050-2242-03

Q935, Q946, Q947, OR Q9070 REPLACEMENT

For the following TEKTRONIX[®] instruments:

Fig. 1. Location of new diode-resistor network.

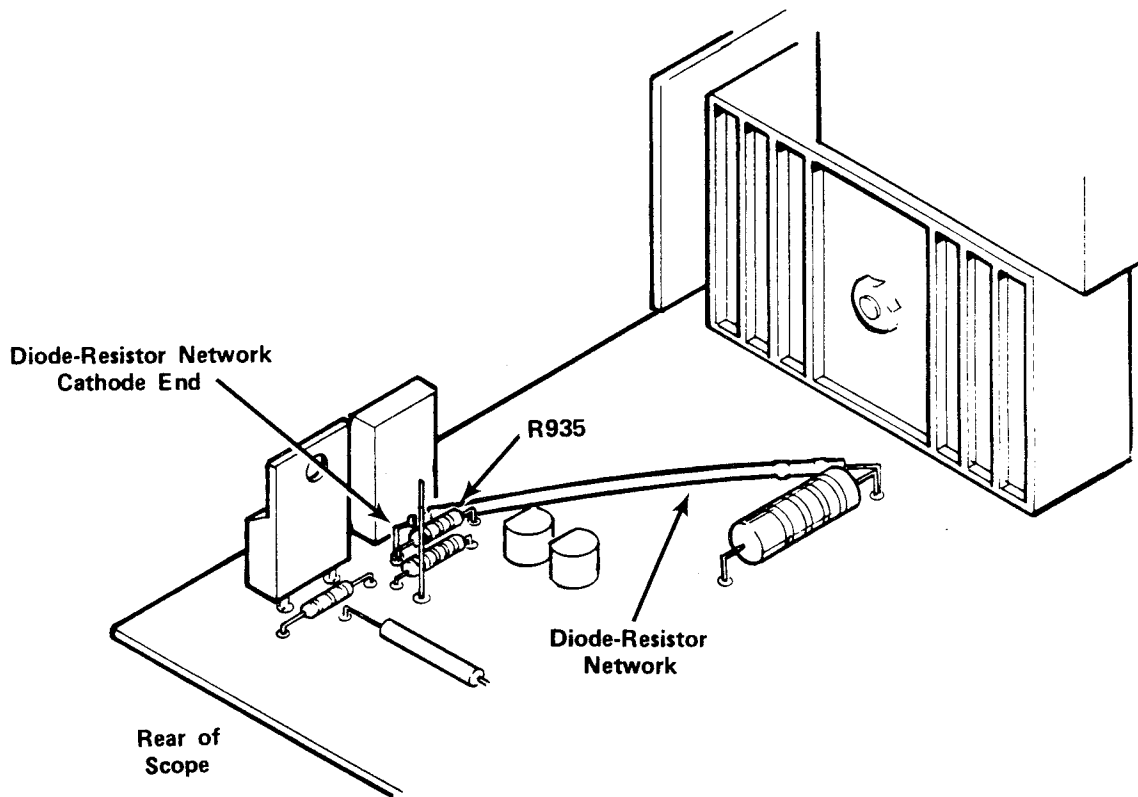
Perform step 10 only if the diode-resistor network shown in Fig. 1 is not present.

- () 10. Install the diode-resistor network, included in this kit, as shown in Fig. 1. Connect the cathode lead to the lead of R935 that is closest to the rear of the instrument. Connect the resistor lead of the new network to the lead of R949 that is nearest the front of the instrument. Ensure both leads of the new network make a solid mechanical connection by installing the leads into the circuit board holes with the resistor leads or by wrapping the network leads around the resistor leads before soldering.
